## **ADDENDUM NO. 1**

**Jack Anderson Ball Park Concessions and Restroom**  
**Meeting Sign-In Sheet**  
**663-005-12**  
**July 22, 2014**

Jack Anderson Ball Park Concessions and Restrooms  
 Ashland, NE  
 TCEP Project No.: 663-005-12

# FIRST FLOOR PIPING PLAN

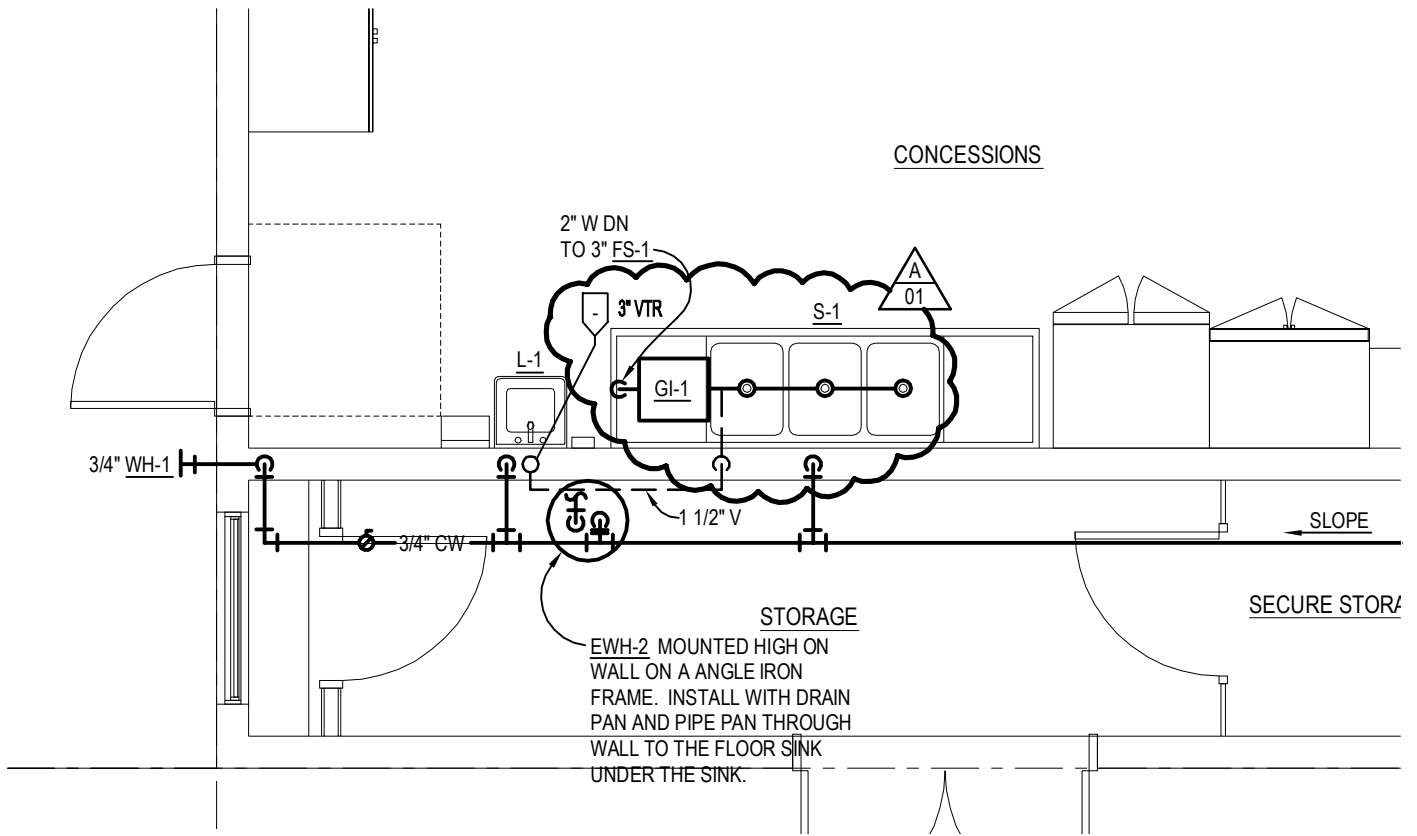
Reference SDM-001 for a revised First Floor Piping Plan to add a grease interceptor location and pipe routing in Concession Room

# WASTE AND VENT RISER DIAGRAM

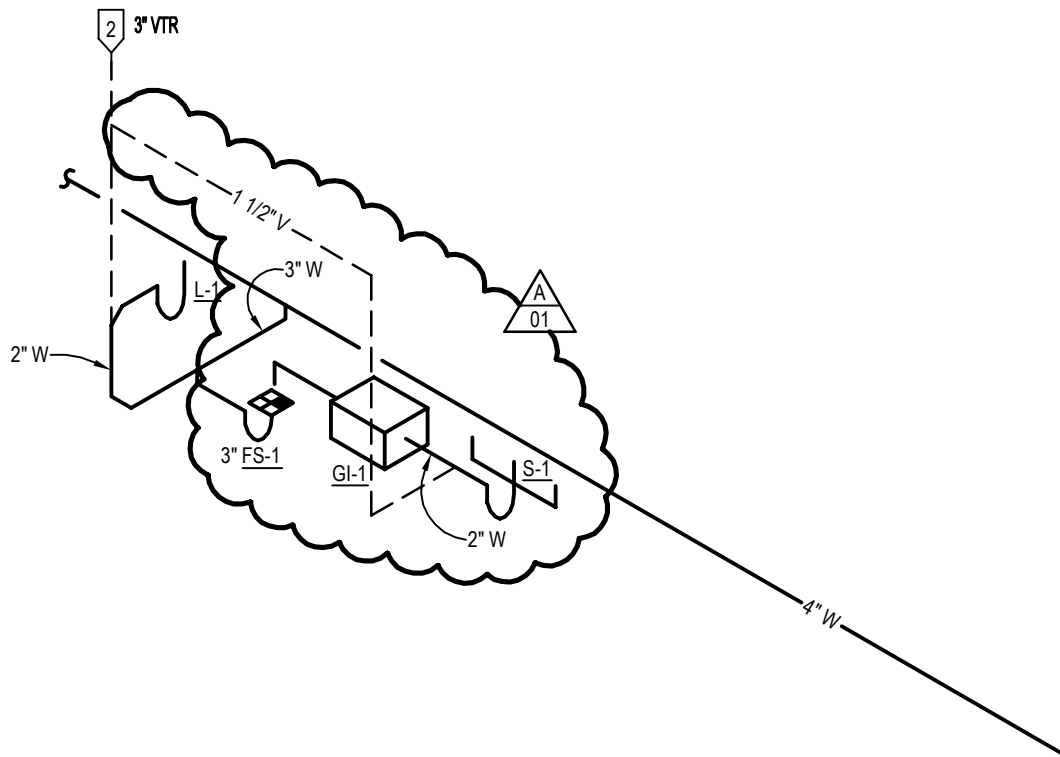
Reference SDM-002 for a revised Waste and Vent Riser Diagram for pipe routing of grease interceptor.
